CITY OF SAN ANTONIO
CAPITAL IMPROVEMENTS MANAGEMENT SERVICES DEPARTMENT

PROJECT NAME: Callaghan Road – Culebra to Commerce
PROJECT NO. 40-00007

DATE December 13, 2010

ADDENDUM NO. 2

DRWN. BY: MH DSGN. BY: RLC CHKD. BY: SDL SHEET NO.: 214 OF 334

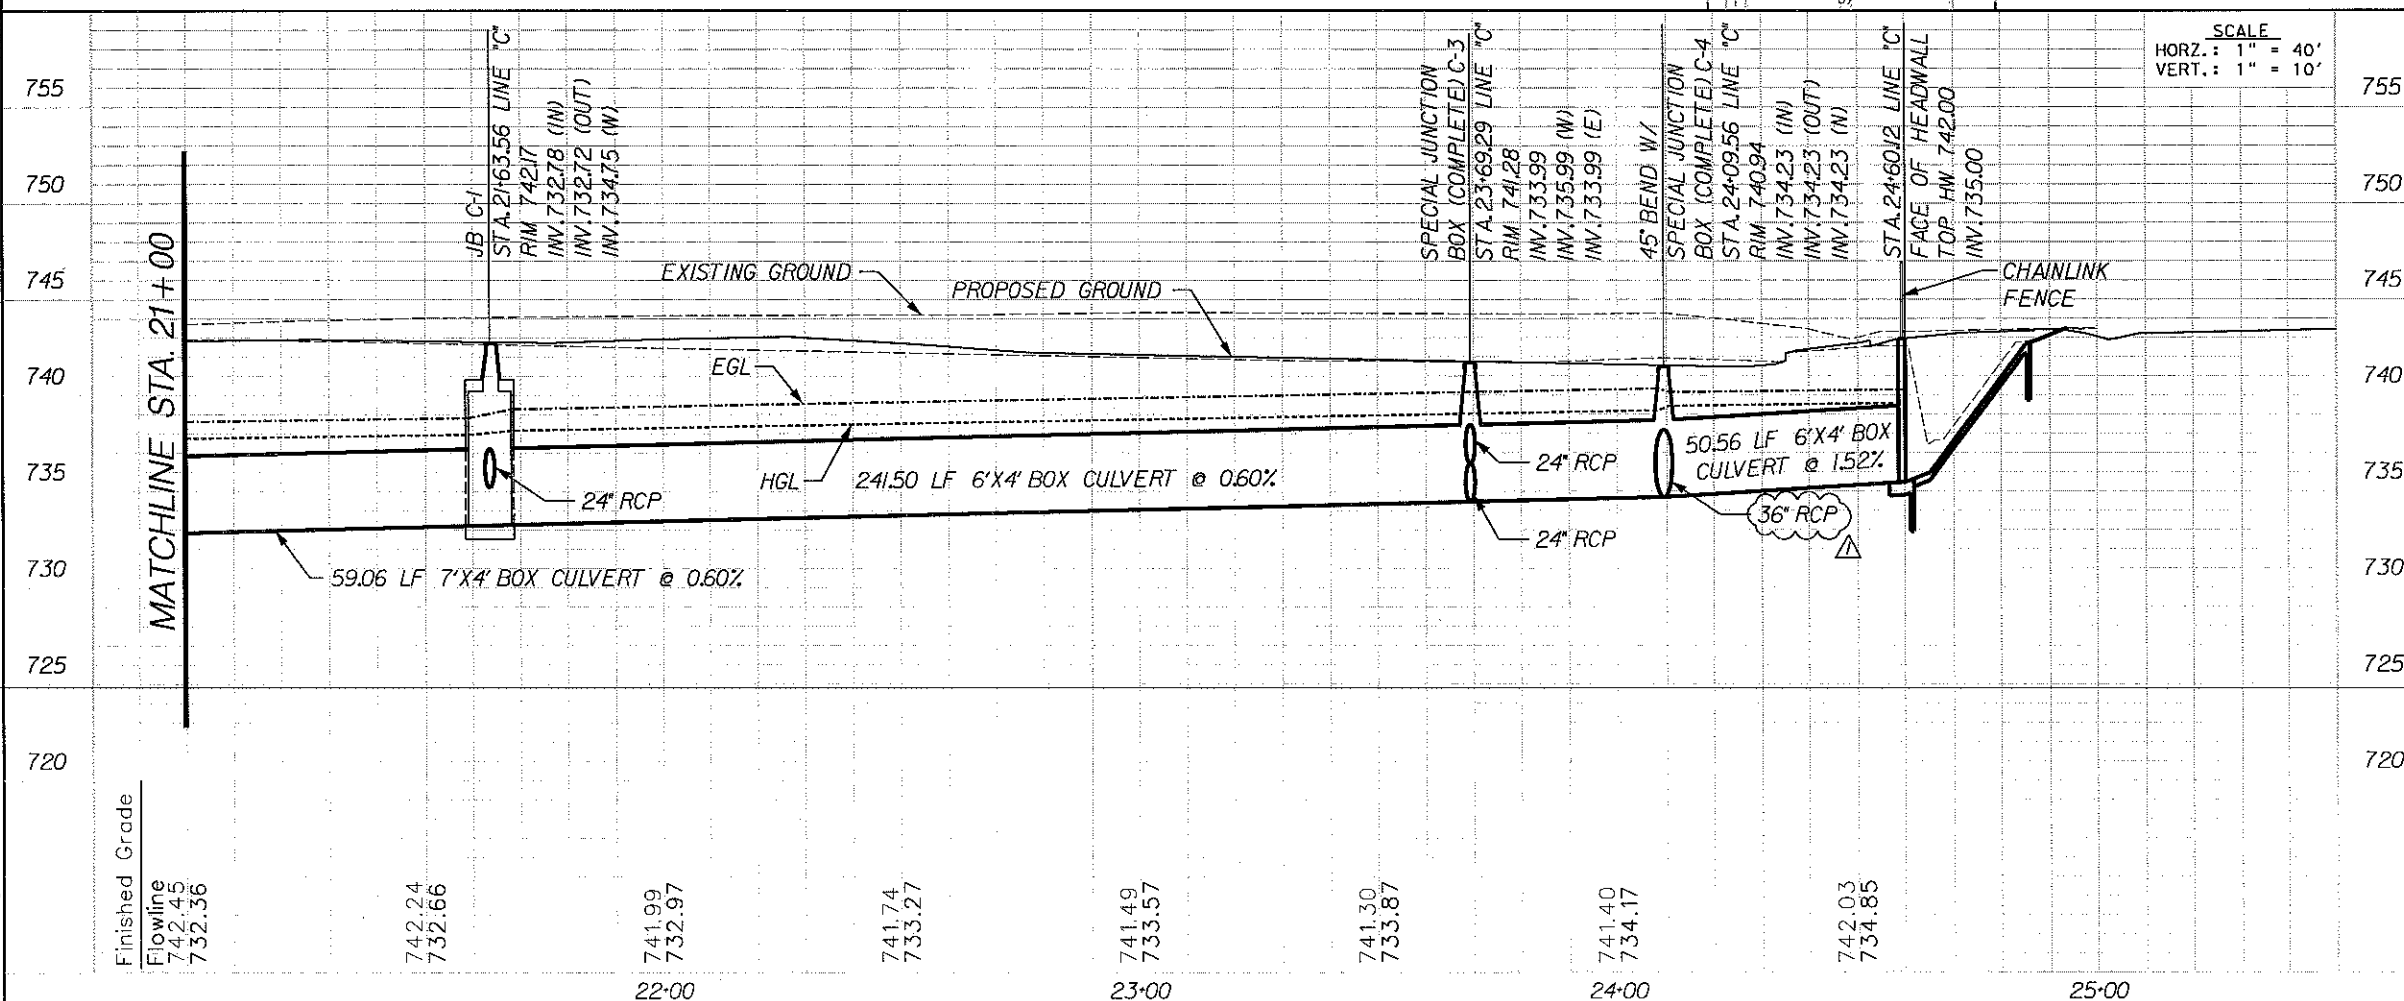
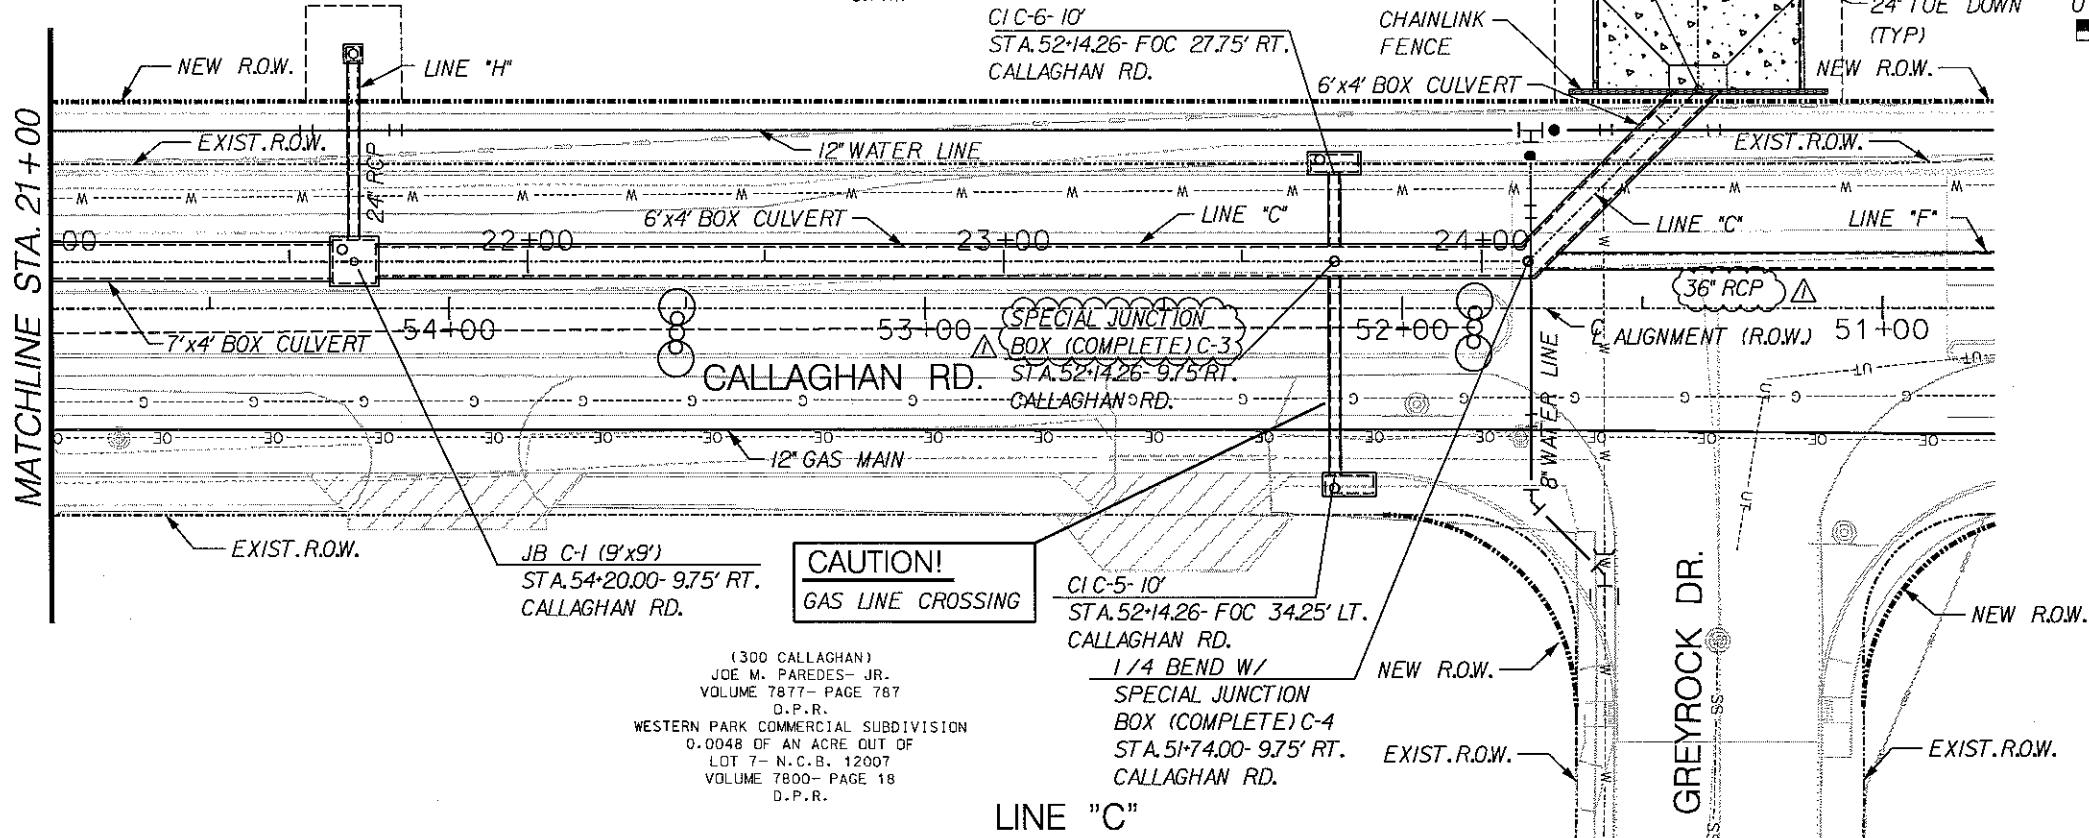
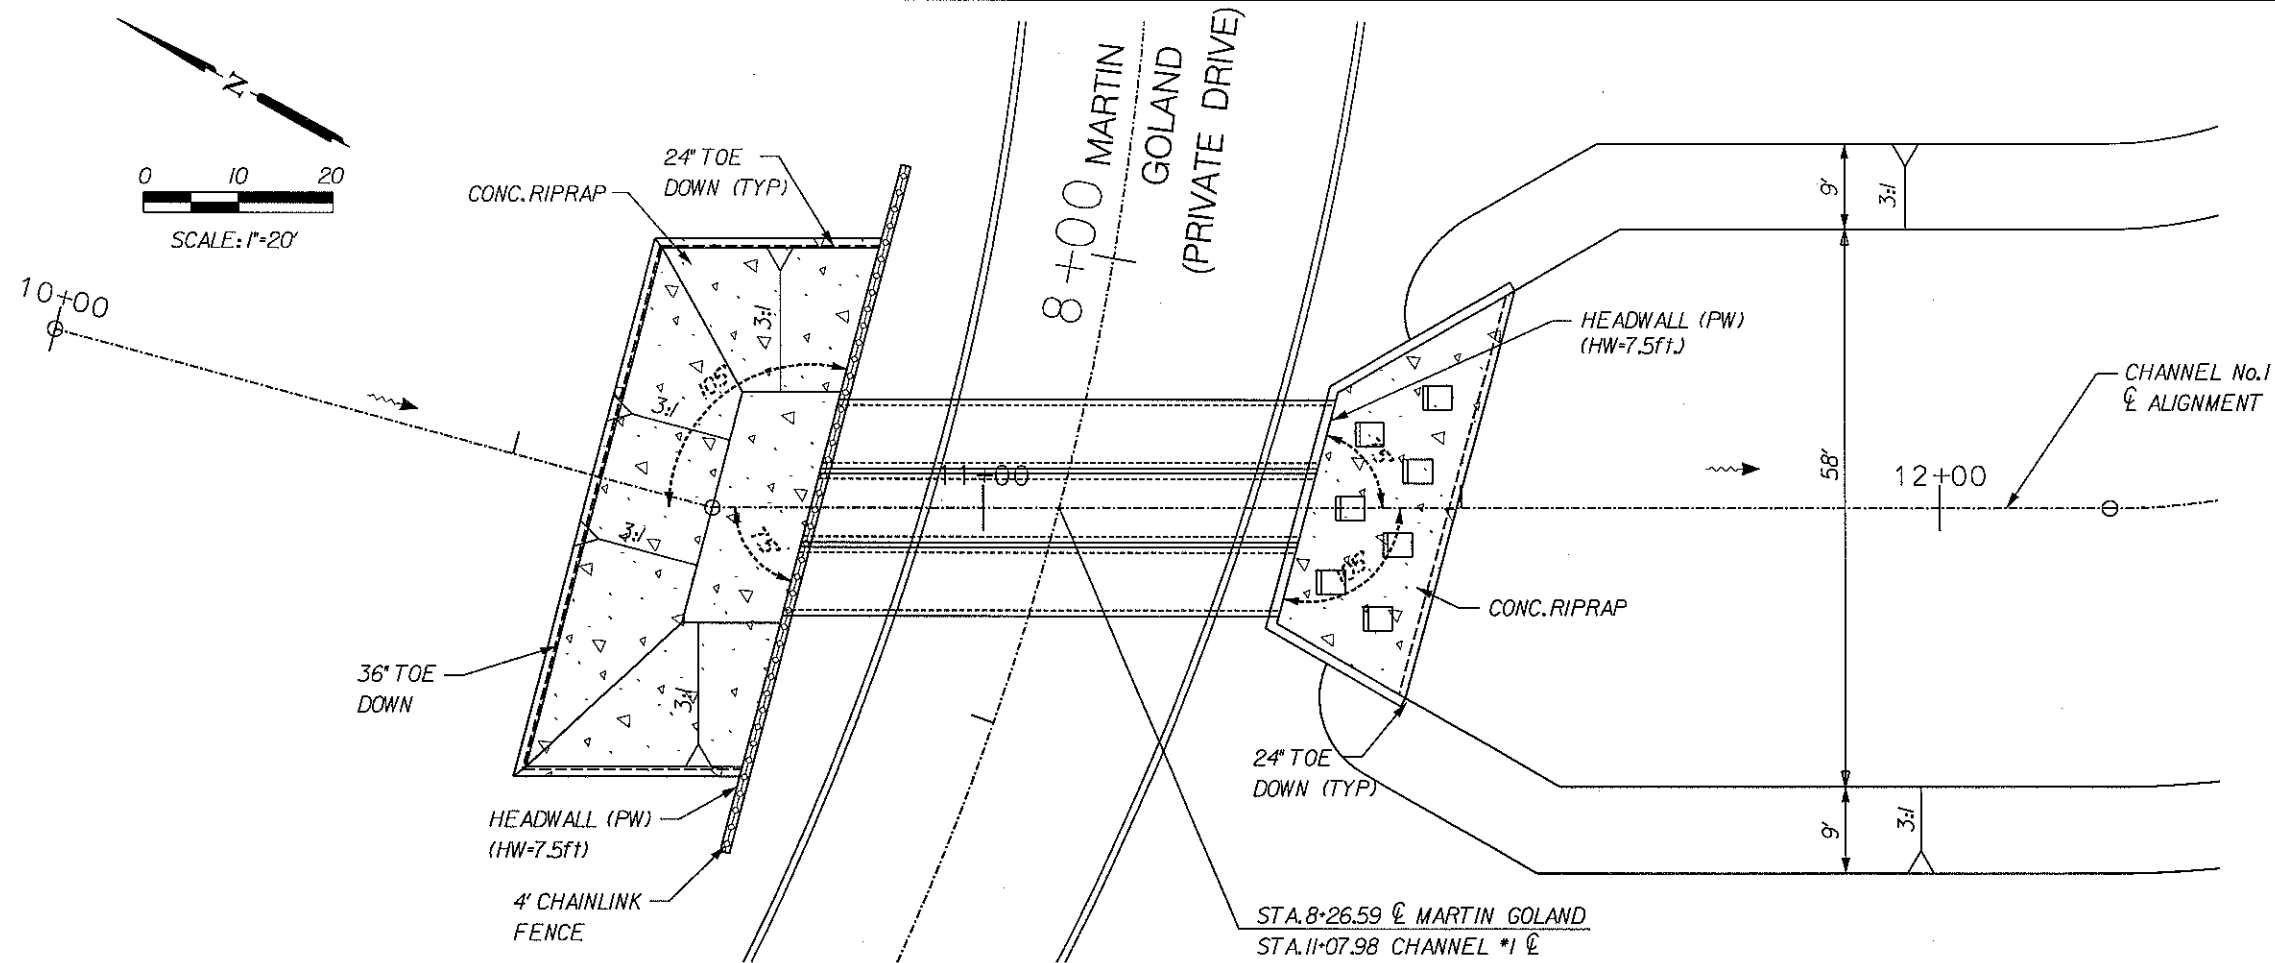
5. Reference Sheet 224, the plan view shows a 42" RCP penetrating into the 6'x4' BC (north side), however we assume that line is really a 36" RCP main. Please confirm.

The pipe shown on Sheet 214 is Line "F" which is a 36" RCP. Sheet 214 has been corrected.

1 JUNCTION BOX AND PIPE PER ADDENDUM #2 12-10-10

SHEET 7 OF 9

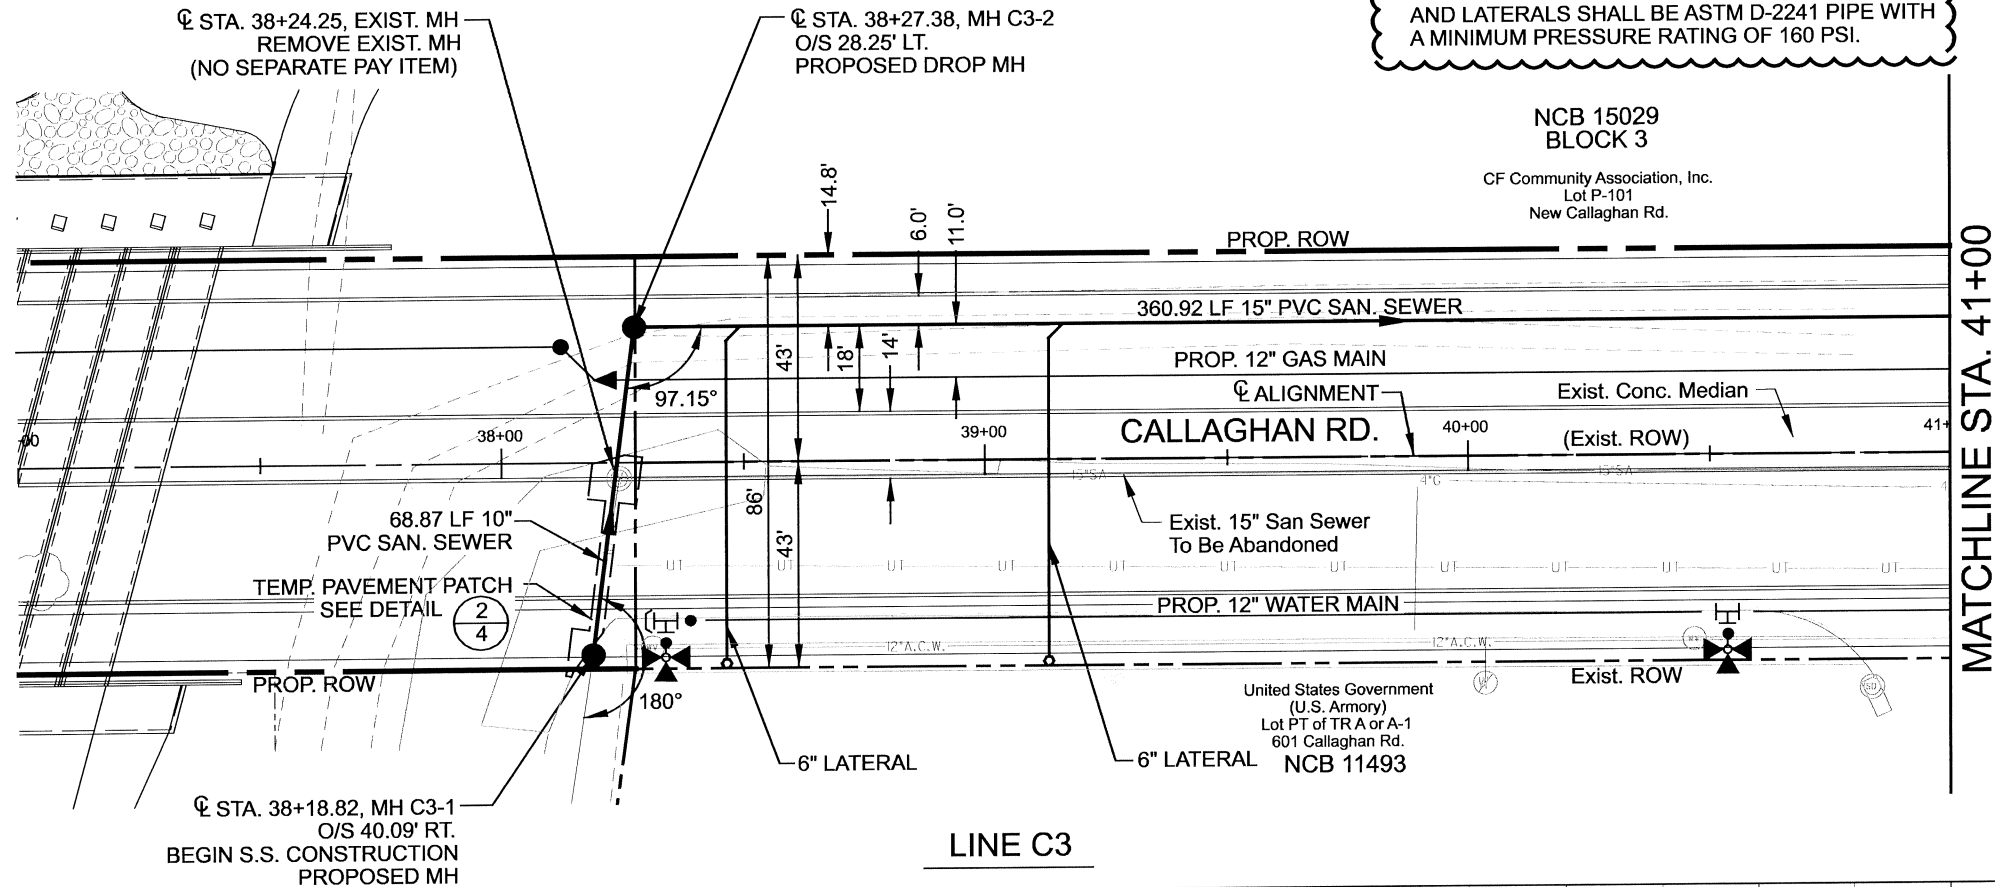
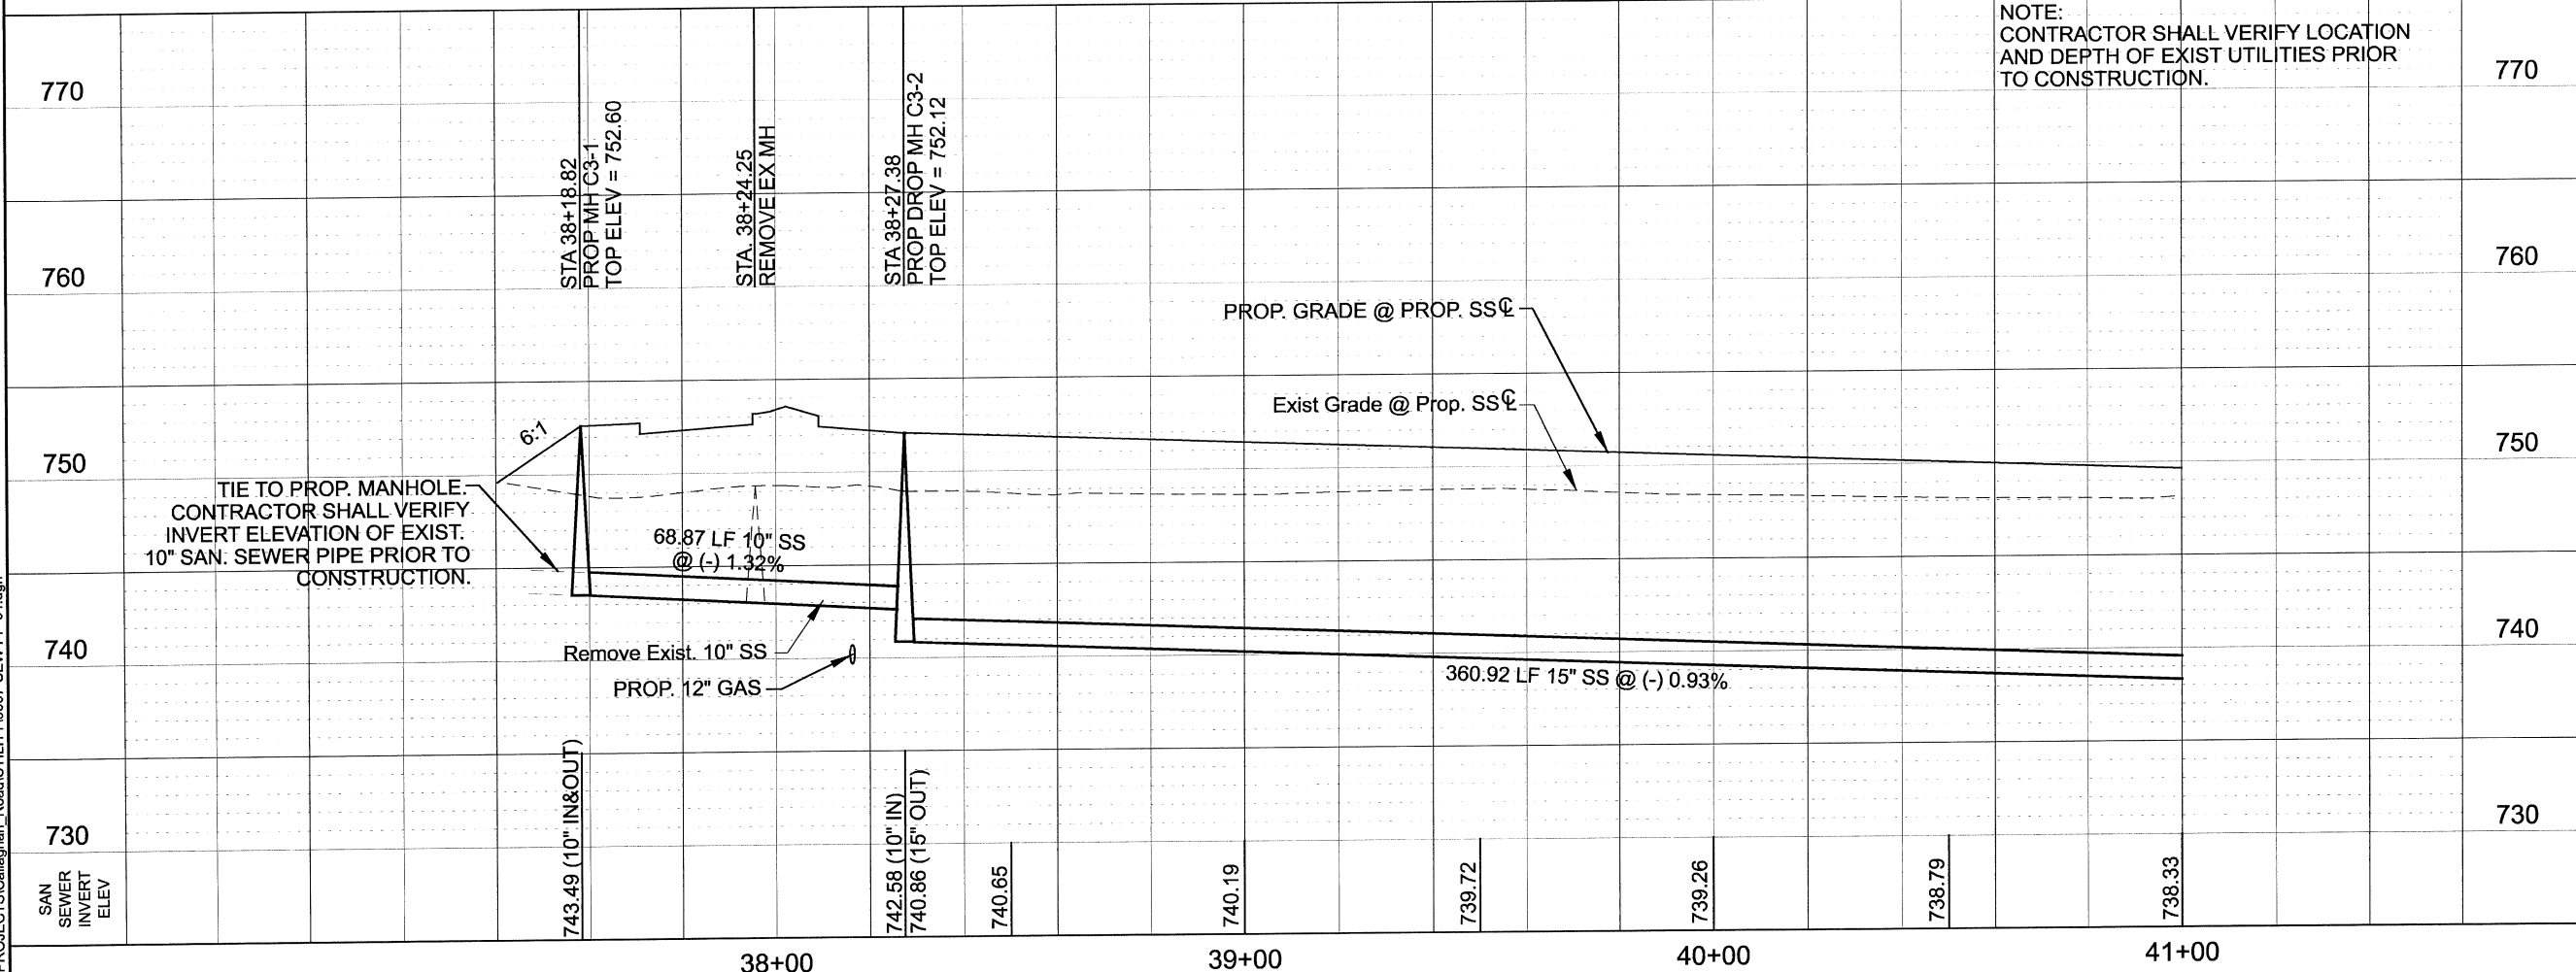
ITEM NO. 6: Sanitary Sewer sheets 7, 8 & 9 have been revised. A note has been changed to read "ALL 15 " SANITARY SEWER PIPE SHALL BE SDR 26 AND ALL LATERALS SHALL BE ASTM 2241 PIPE WITH A MINIMUM PRESSURE RATING OF 160 PSI". Sheets attached.

ALL 15" SANITARY SEWER PIPE SHALL BE SDR 26 AND LATERALS SHALL BE ASTM D-2241 PIPE WITH A MINIMUM PRESSURE RATING OF 160 PSI.
